PRELIMINARY OVERALL AREA DEVELOPMENT PLAN - P.O.A.D.P.
PRELIMINARY MASTER PLAN BY TRACT
WOODLAND HILLS - I.H. 10 NORTH
1320.8 ACRES

INFORMATION SHEET FOR
PRELIMINARY OVERALL AREA DEVELOPMENT PLAN
(P.O.A.D.P.)

RE: Woodland Hills Plan #248

RE: Woodland IH-10 North Loop
POADP #248

• FIRE DEPT. TURN-AROUNDS

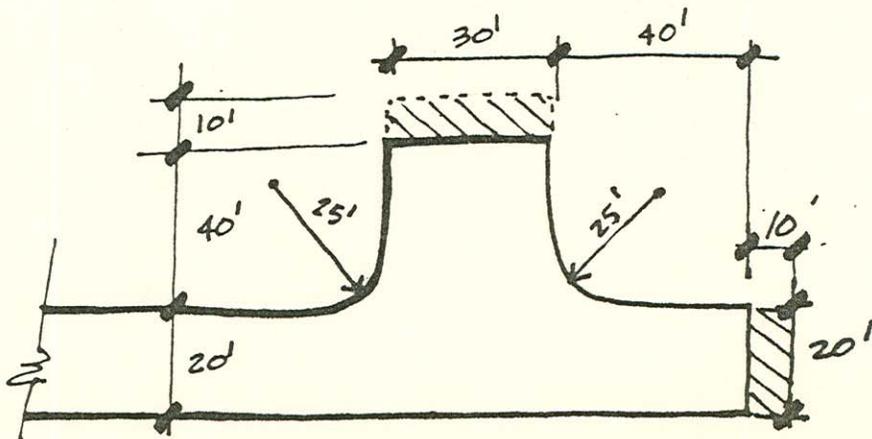
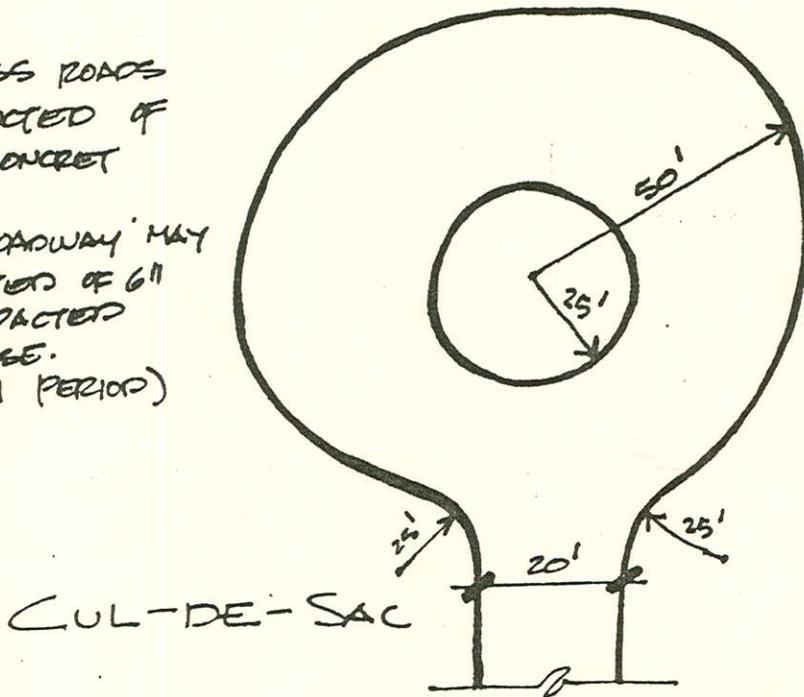
1. Our ladder trucks are needed at nearly every residential fire. Due to the approximately 47 foot length of the truck, a turnaround with a 50 foot radius to the curb line is needed. The option of backing up the truck as much as 1000 feet is not favorable, especially considering the good chance of having to backup while traveling downhill.

Within the city limits the department requires building owners to provide an approved turnaround if a dead-end access road exceeds 150 feet.

A turnaround for ladder trucks at the end of the cul-de-sac, and an intermediate turnaround for pumpers no more than 500 feet into the cul-de-sac would be more appropriate.

2. Any intermediate streets that would be used as a turnaround should be designed in a manner approved by the department. Attached is a copy of approved turnaround designs.
3. The technology is available to install a life-safety residential sprinkler system inexpensively. The department is willing to consider incentives so that a win-win situation is created. Hopefully by working together we can figure out a way to economically develop the property and also provide a high level of life safety.

1. This item deals with the intermediate turnarounds that we have provided on the POADP. In addition, it also addresses a requirement for a 50-foot radius turnaround. Current City regulations for cul-de-sacs require a 50-foot radius to the right-of-way and a 40-foot radius to the curb line. When the Woodland Hills property is developed, we intend to comply with the subdivision requirements in place at that time.
2. It is our belief that all street intersections meet this criteria.
3. While we do not disagree with maintaining a high level of life safety, we do not feel it is appropriate for this issue to be addressed specifically for a single development. We feel this issue must be dealt with on a city wide basis.
